CITY OF ALBUQUERQUE

Re: Wat Buddhocothorn-Vibes Buddhist Temple
139 Madison St NE
Traffic Circulation Layout
Architect's Stamp dated 07-27-16 (K17D112)

TRAFFIC CIRCULATION LAYOUT

TCL-101

A1 TRAFFIC CIRCULATION LAYOUT

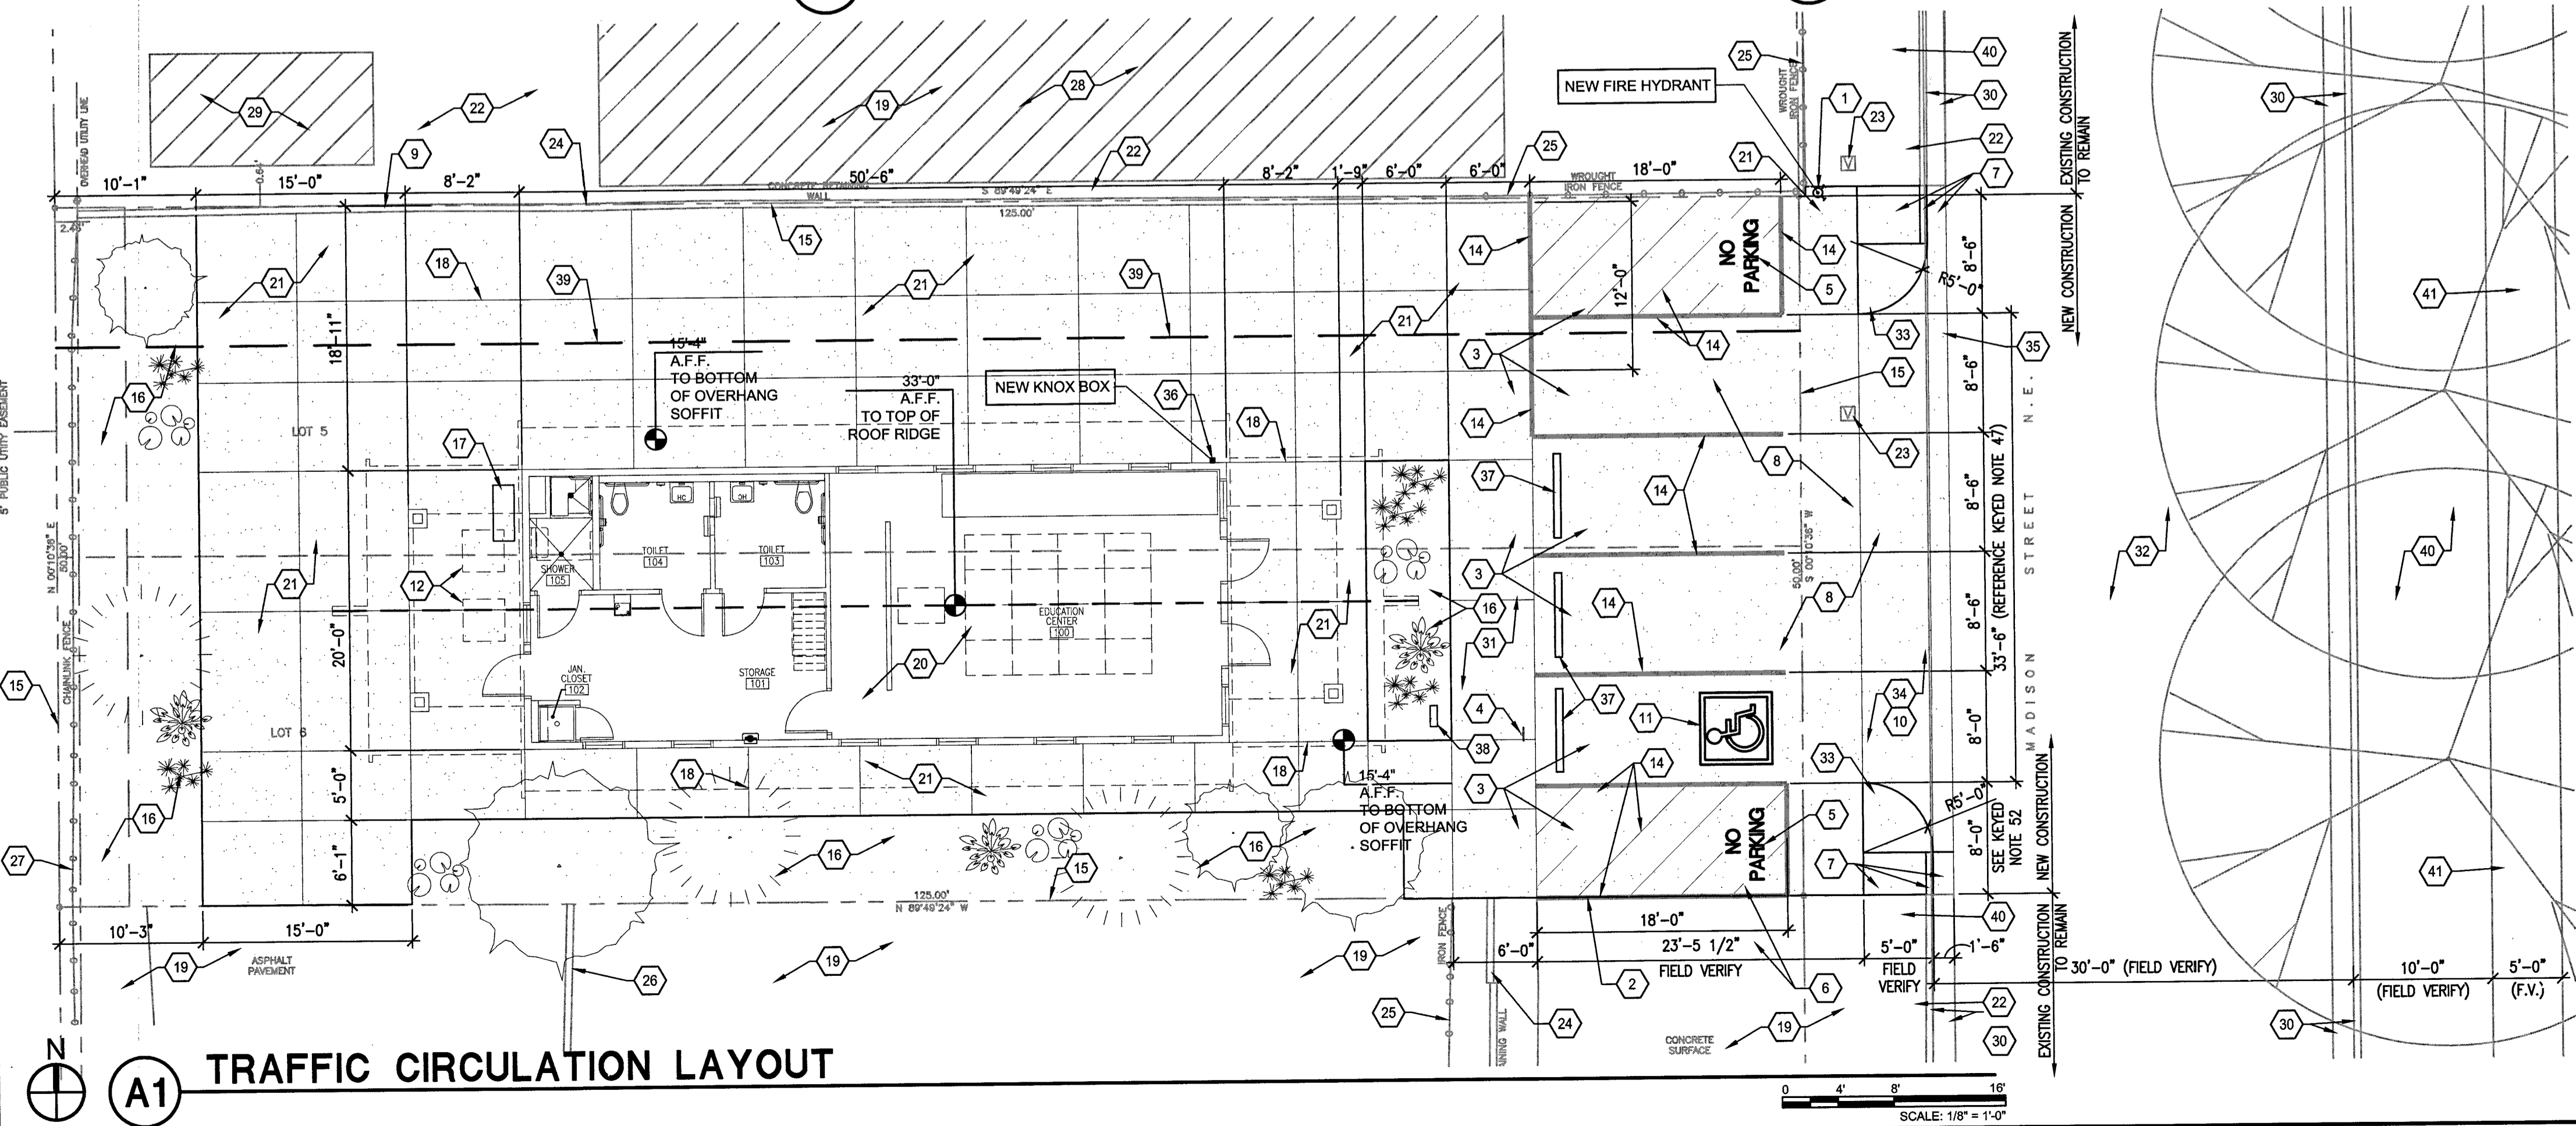
1. The ADA accessible parking sign must have the required language per 66-7-352.4C NMSA 1978 **"Violators Are Subject to a Fine and/or Towing."** Please call out detail and location of HC signs.
2. The ADA access aisles shall have the words **"NO PARKING"** in capital letters, each of which shall be at least one foot high and at least two inches wide, placed at the rear of the parking space so as to be close to where an adjacent vehicle's rear tire would be placed. (66-1-4.1.B NMSA 1978)
